UNITED STATES
DEPARTMENT OF THE INTERIOR
BUREAU OF LAND MANAGEMENTFORM APPROVED
OMB NO. 1004-0137
Expires: January 31, 2018**SUNDRY NOTICES AND REPORTS ON WELLS**
*Do not use this form for proposals to drill or to re-enter an abandoned well. Use form 3160-3 (APD) for such proposals.*5. Lease Serial No.
NMNM61349

LONGVIEW FEDERAL 6 011

RKI EXPLORATION & PRODUCTION RESPECTFULLY REQUESTS TO P&A THE ABOVE MENTIONED WELL.
THE WBD AND PROCESS ARE ATTACHED.

Longview Fed. #6-11 Plug and Abandon Procedure

**Longview 6 #11
Proposed WBD**

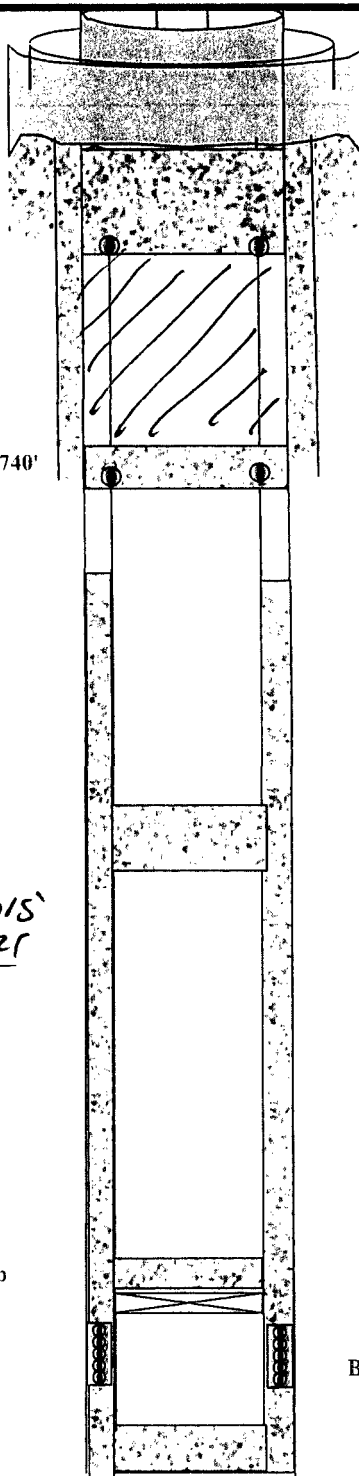
*DVT @ 5015'
5021'*

2nd stage 975'

1st stage 512'

B/calf 2635'

Del. 2915' ✓

- 7) PU & LD tbgs. to 5,044' - Spot 30 sxs from 5,044' - 4,875' (over DV Tool).. *WOC Tag.*
- 8) PU & LD tbgs. - Stand back 2500' of tbgs.
- 9) RU WL & Perforate 4 holes @ 2,891'. RD MO wireline. *Solid Plug from 2891 - 472 in/out of 5 1/2" casing through Potash. WOC Tag. If in stages perfs @ cmt top required.*

- 11) ~~WOC & Tag @ 2,740'.~~ *472 Tag*
- 12) RU WL - Perf @ 343' - Attempt to establish pump rate. Squeeze 140 sxs. cmt. - if unable to circulate, LD Pkr., RIH w- tbgs. to 393' & spot 45 sxs. cmt. to surface.
